47 Jugan St, Mt Hawthorn

Planning Stage Acoustic Report

P180500RP1 Revision 0

Figure 1: Ground floor BCA/NCC markup

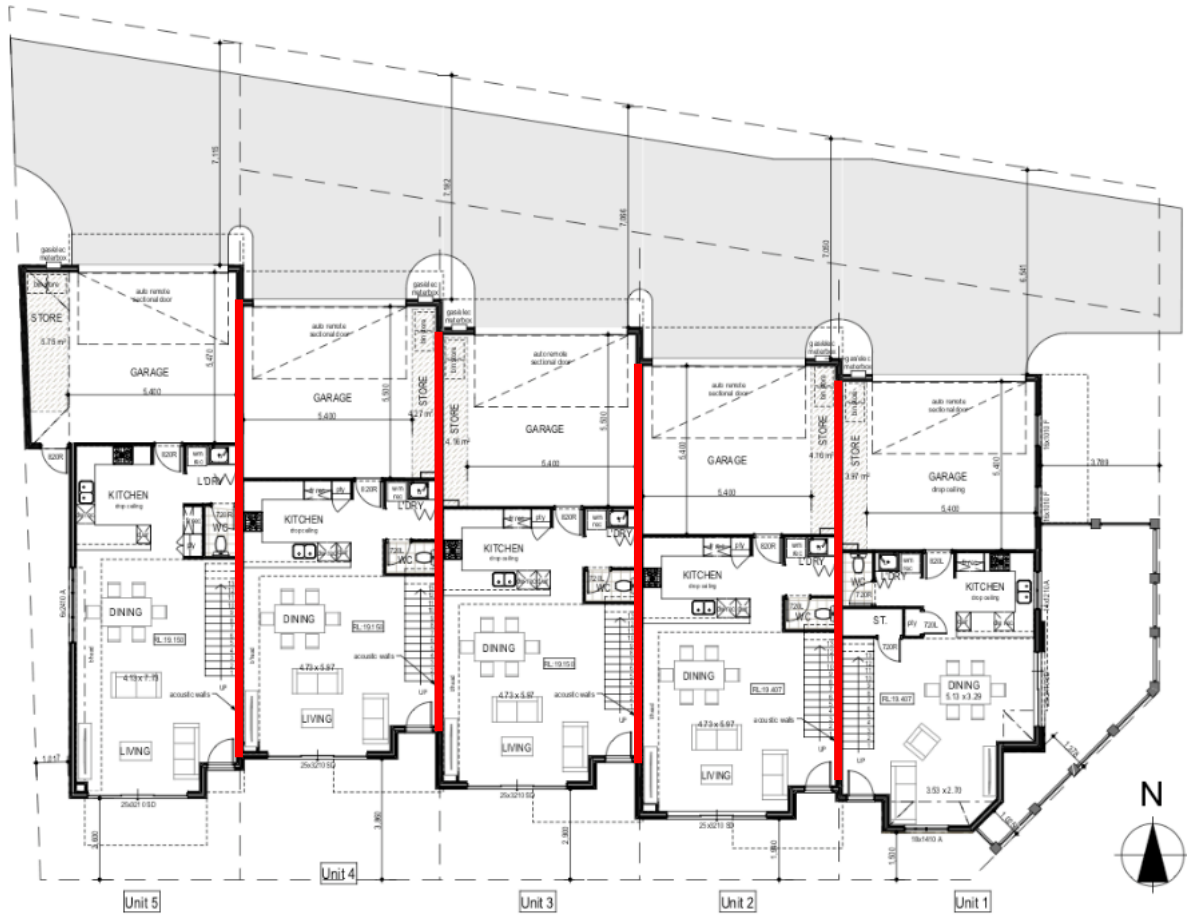
The acoustic requirements applicable to this development are outlined in Table 1. Refer also to Figures 1 and 2 for a markup of the required acoustic treatments to meet the NCC for residential apartments.

Figure 3: Ground floor glazing markup

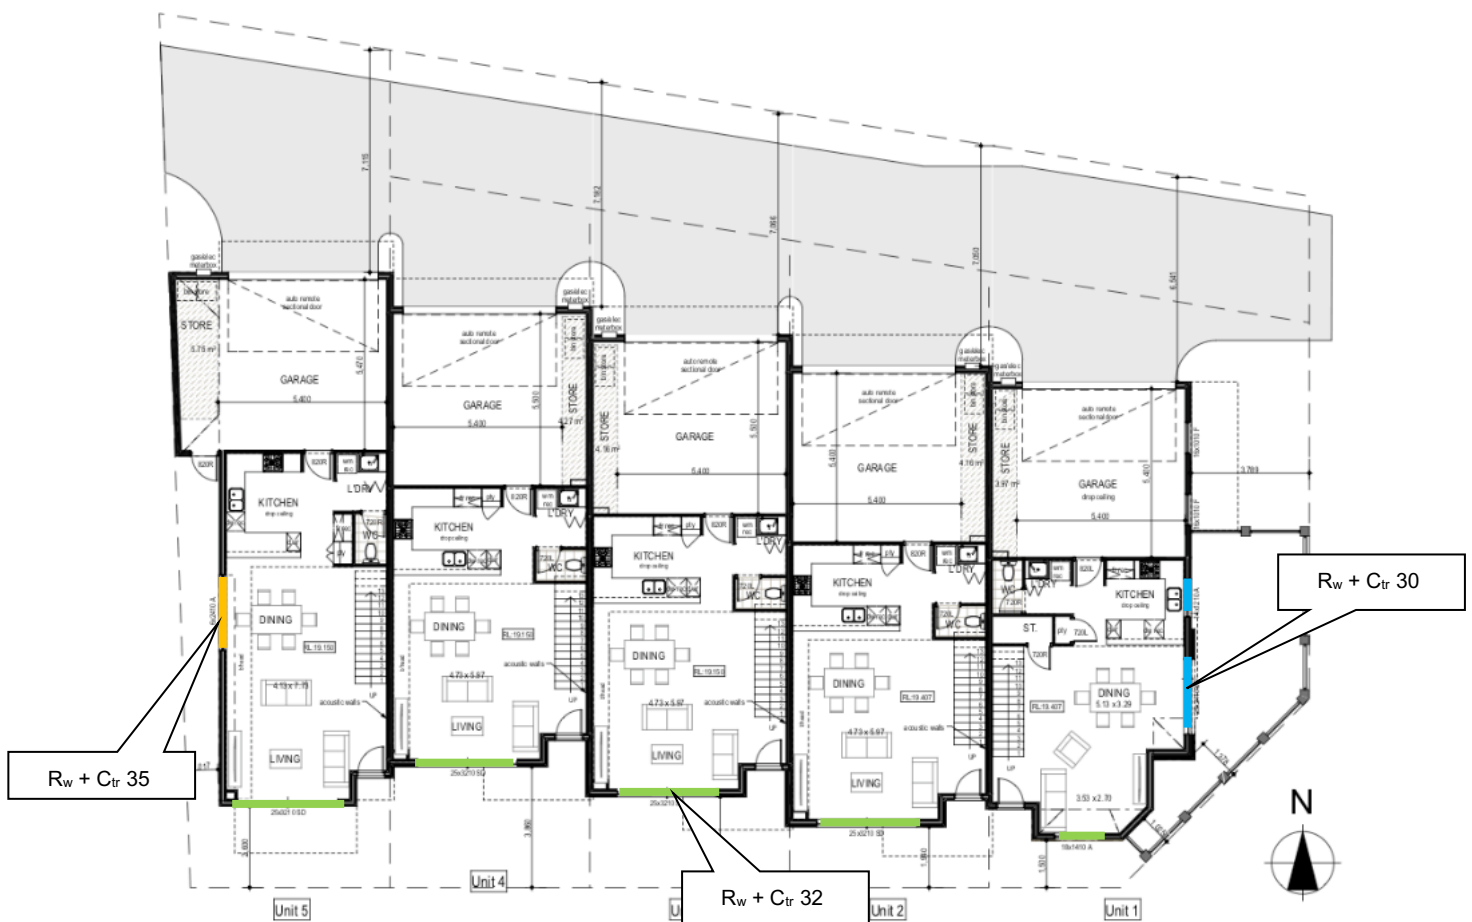
Glazing systems selected are to possess a laboratory test certificated to demonstrate that they meet the minimum requirements specified in Figure 3 and Figure 4, noting that performance is strongly dependent on the frames and seals of a selected system rather than the glass thickness alone. The NRC 0.9 acoustic lining required on nominated balconies may be Reapor 50 mm, Stratocell Whisper 50 mm, or equivalent.
